Service Letter No. 109

October 15, 1947

SUBJECT: J3, PA-11 and PA-12 Winter Operation Recommendations

FIGURE 1 LANDING GEAR STRAP REINFORCEMENT

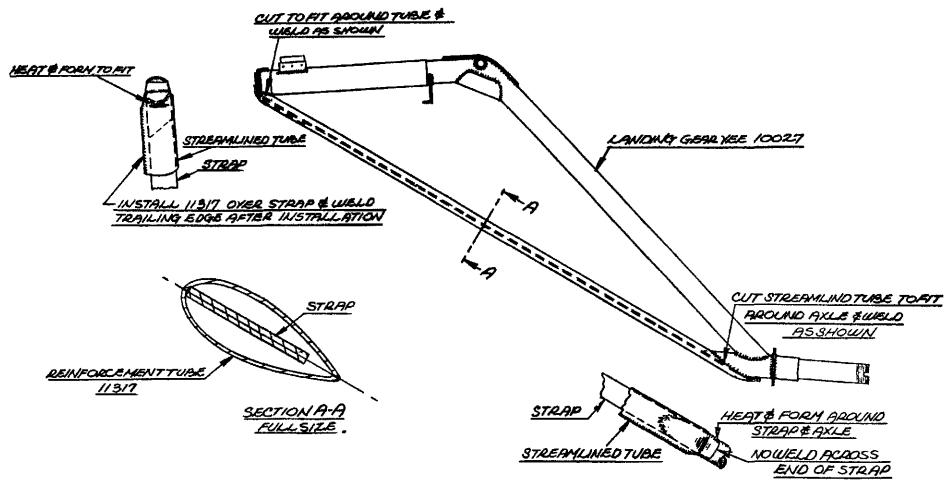
Due to additional stress loads being applied on the landing gear, encountered during ski operation on PA-12 Aircraft, it is recommended that a streamline tube, Piper part number 11317 (two (2) required), be installed over the landing gear strap, as shown on the sketch on opposite side of this letter, which is taken from Piper drawing SK-198.

Installation of the streamline tube reinforcement strap, as mentioned above, is not only recommended for ski operation, but also for operation on rough and rolling fields, particularly at high altitudes where aircraft landing speeds are considerably higher than those encountered at near sea-level operations.

This added reinforcement to the strap is an additional brace for the purpose of carrying any extreme compression loads which may be induced in the plane of the strap, due to inertia, or side loads, which are apparently being encountered in landings while operating on skis, or on severely rutted and rolling fields.

This landing gear strap reinforcement does not eliminate Service Bulletin No. 93 or 97 compliance.
